On behalf of Clayton Properties Group LLC, CORE Consultants, Aztec, Fox Tuttle Transportation Group, and Terracina Design, we have reviewed the comments from the Second Submission Review for the Prairie Point Golf Site Plan. The following is a response to comments:

Second Submission Review

PRAIRIE POINT GOLF COURSE
AURORA, COLORADO
SITE PLAN
COVER

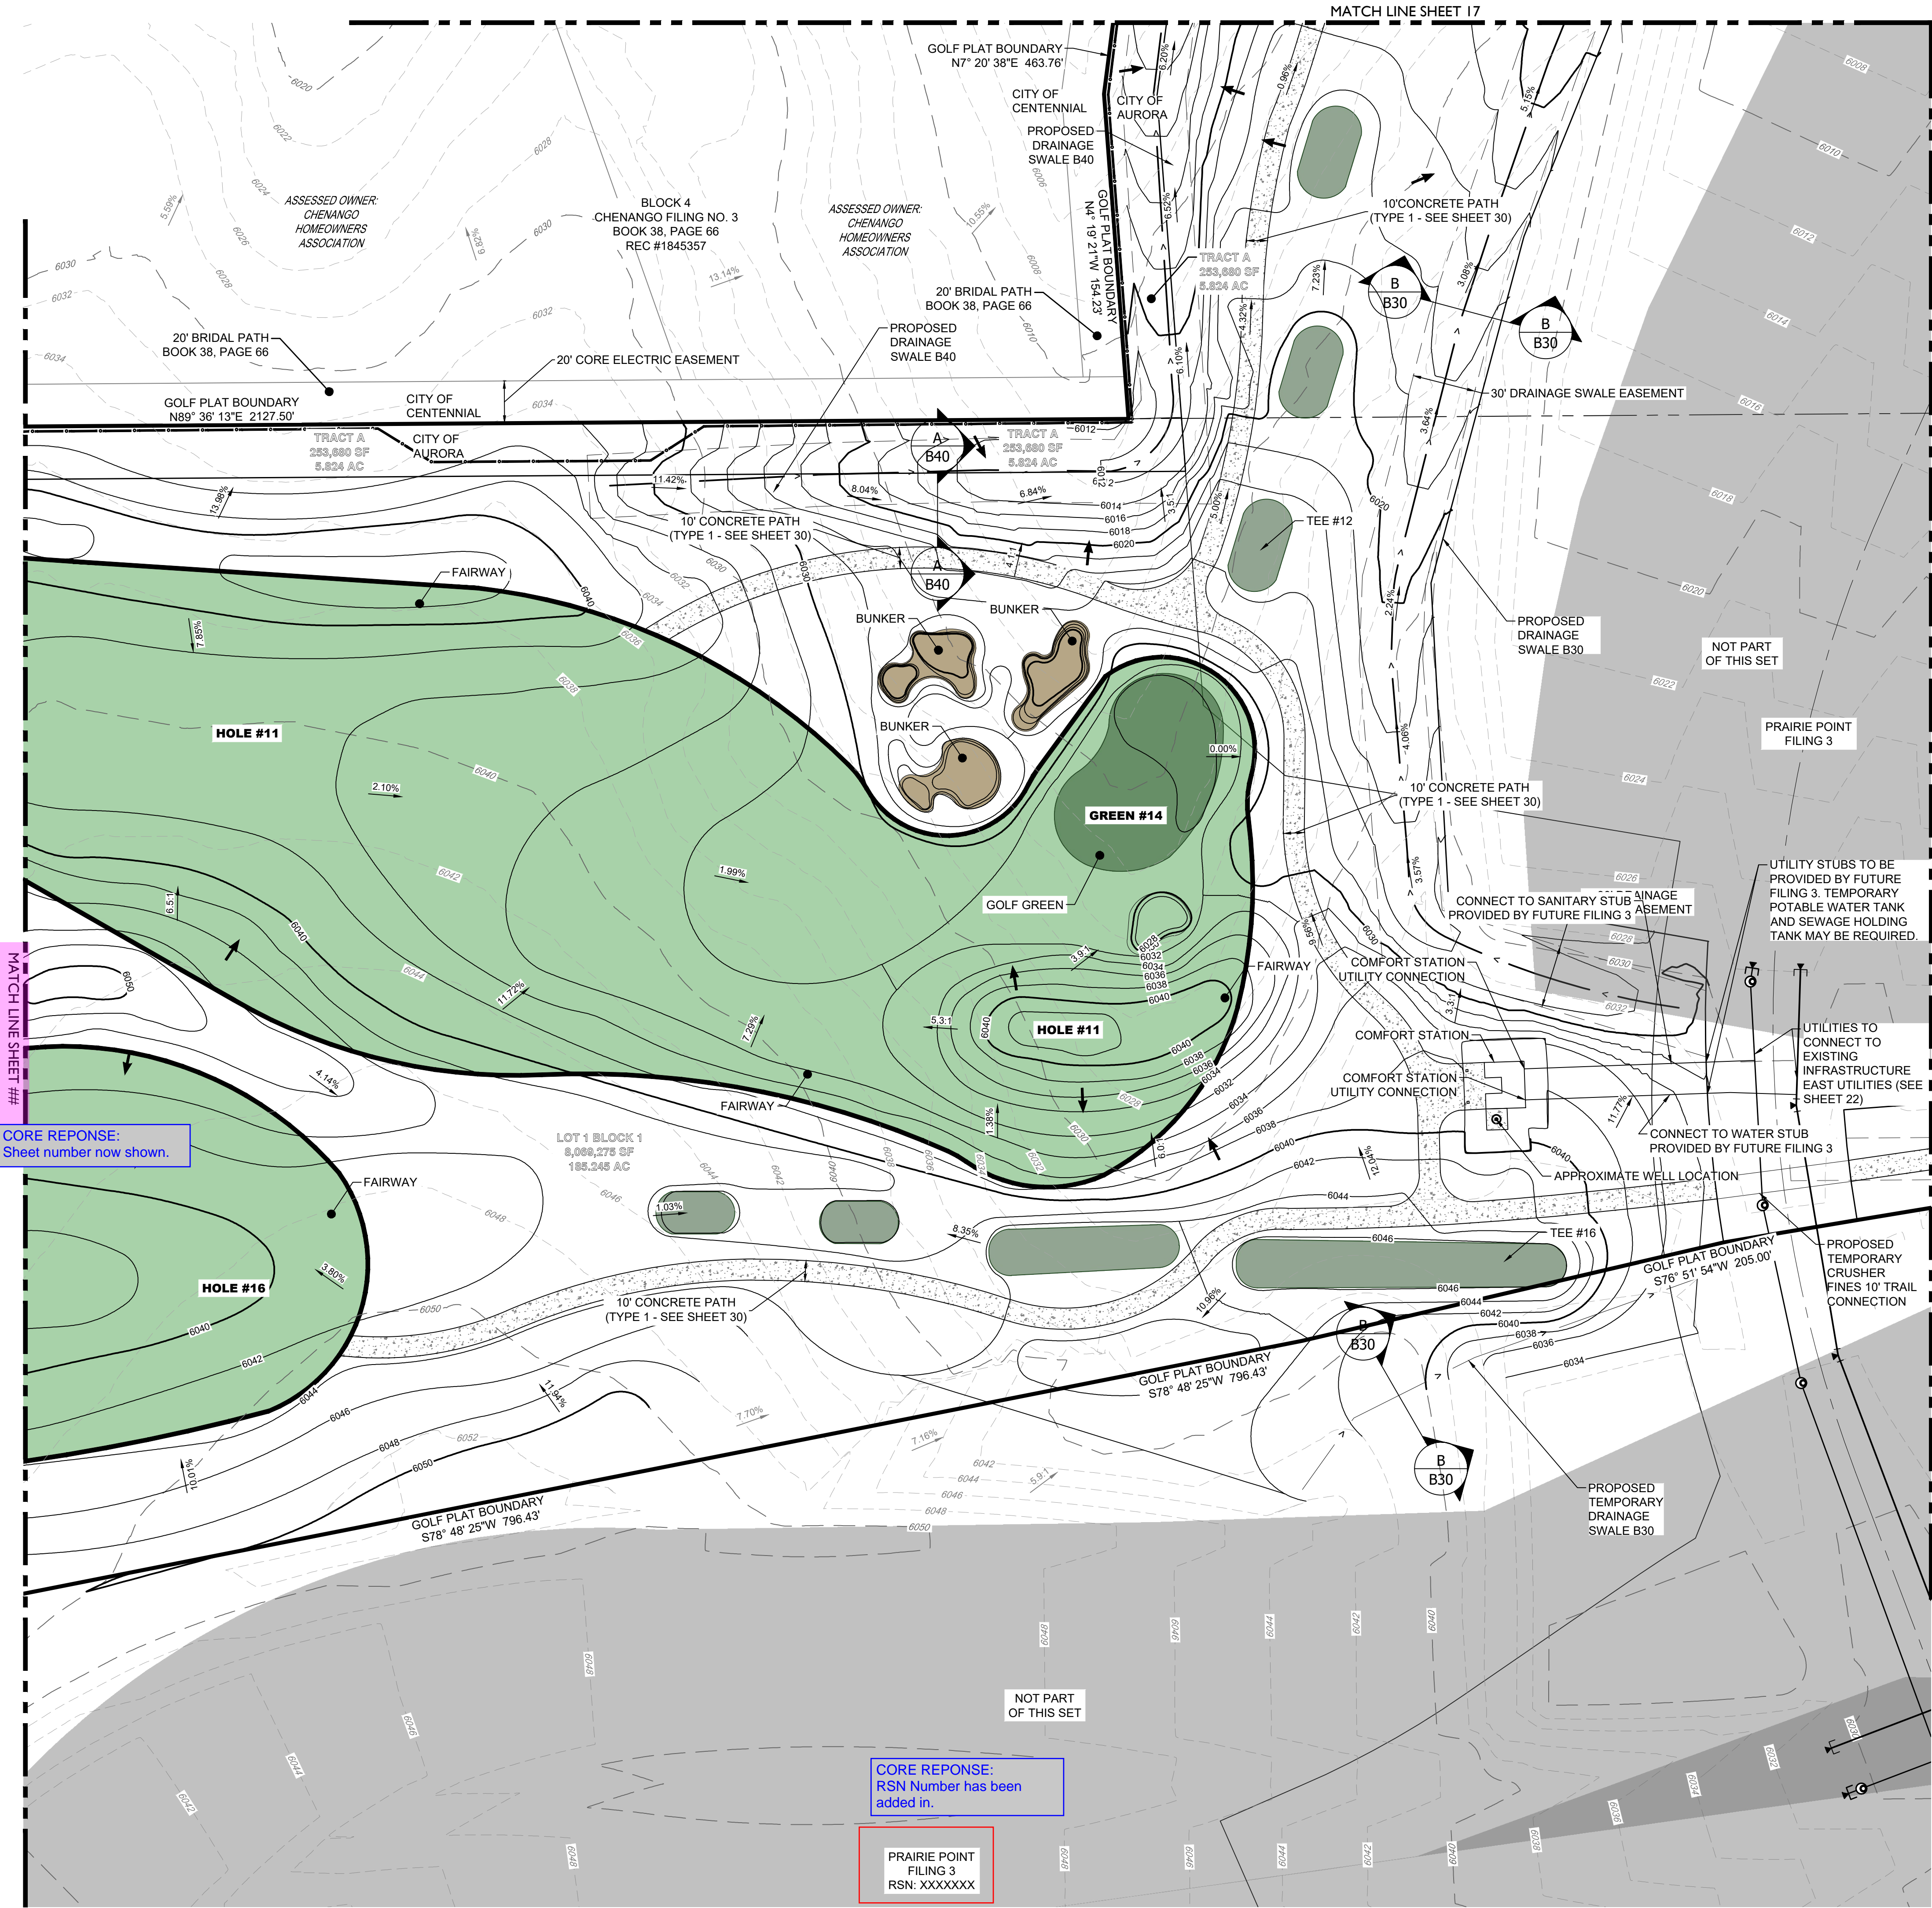
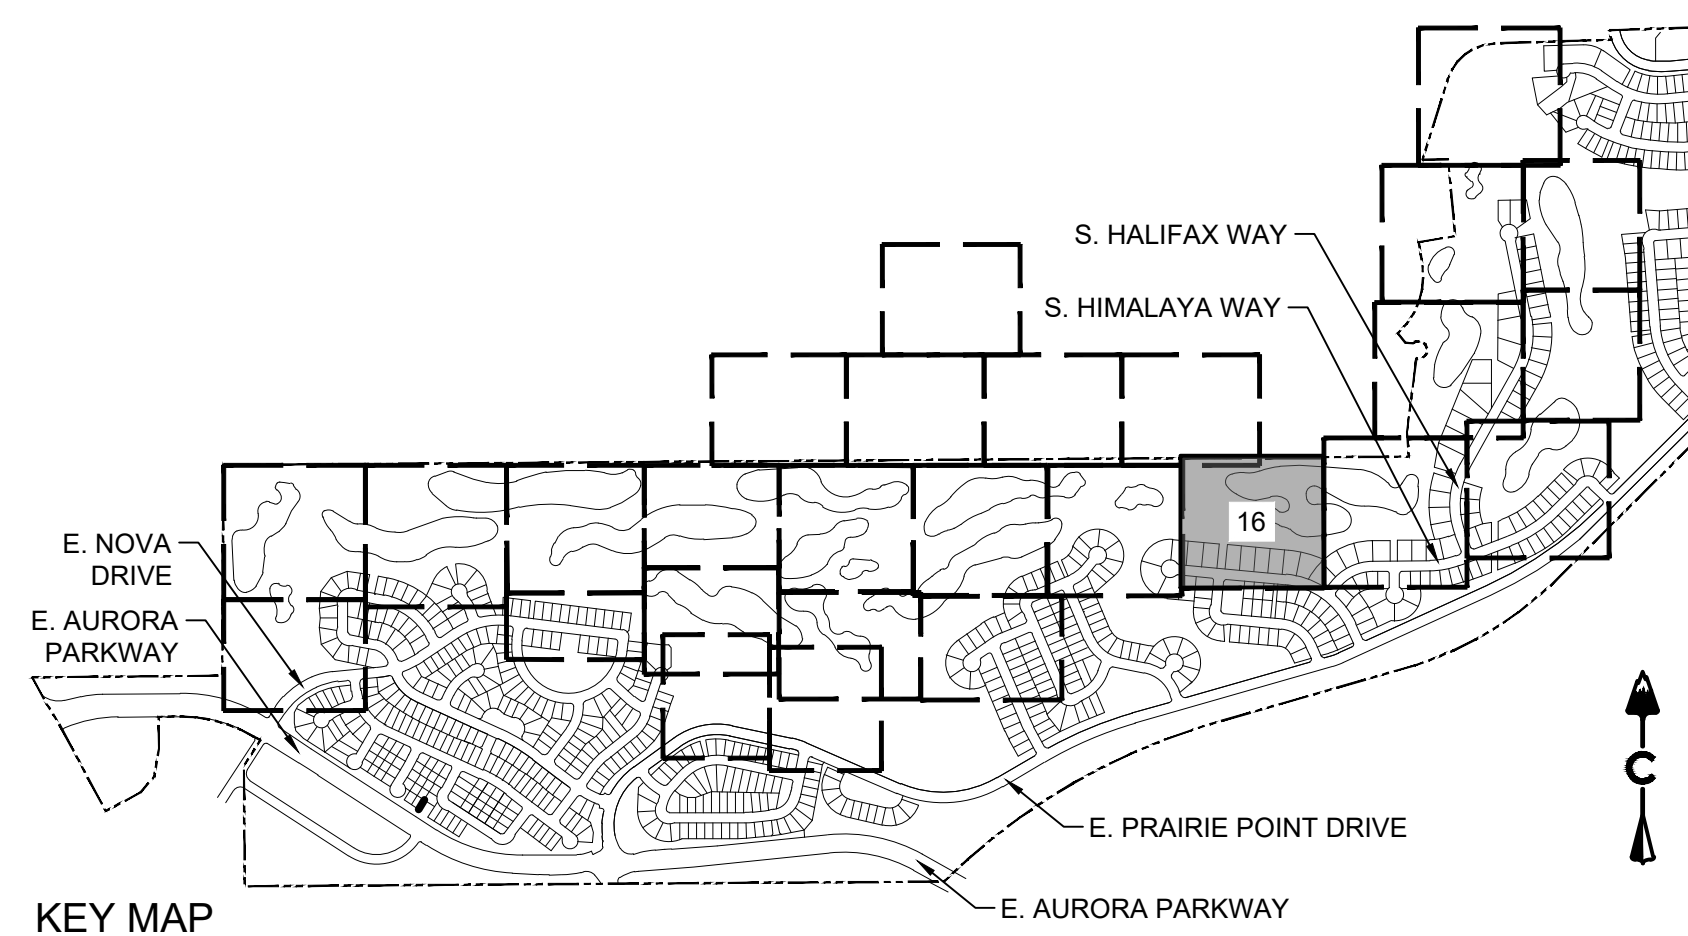
Identify this box or delete

CORE REPONSE:
Line work has been removed.
